Comments 13 –Thomas Skolnicki tjskolni@ncsu.edu, March 8, 2012

NC State University Comments
 March 8, 2012

Proposed Framework Plan
 Blue Ridge Road District Study

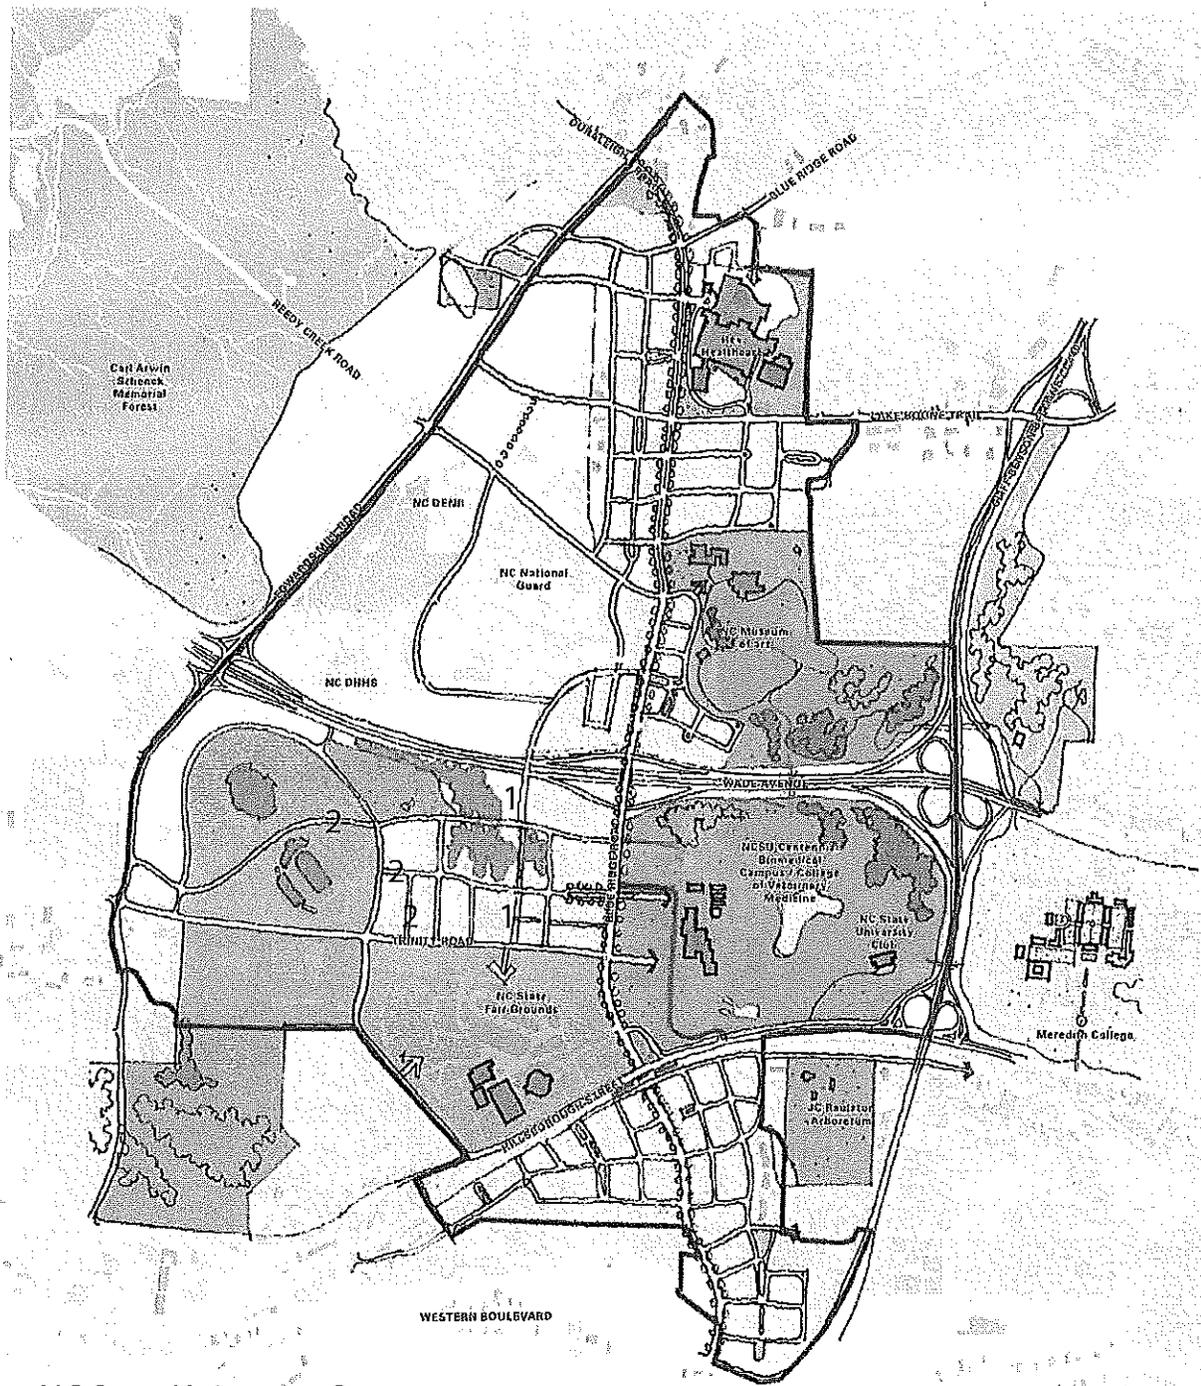
Regarding the map that was produced during the charrette, we would like some more information regarding two issues. I have keyed the areas on the attached plan according to the numbers below:

1. Please clarify where the proposed street west of Blue Ridge Road (that would bridge Wade Ave.) would be in relation to existing property lines between Wade Avenue and Trinity Road.
2. Please clarify the intent of the roads shown in the area of Carter-Finley Stadium. Are each of these drawn in new locations? If so, please clarify the intent and any impact to the parking areas.
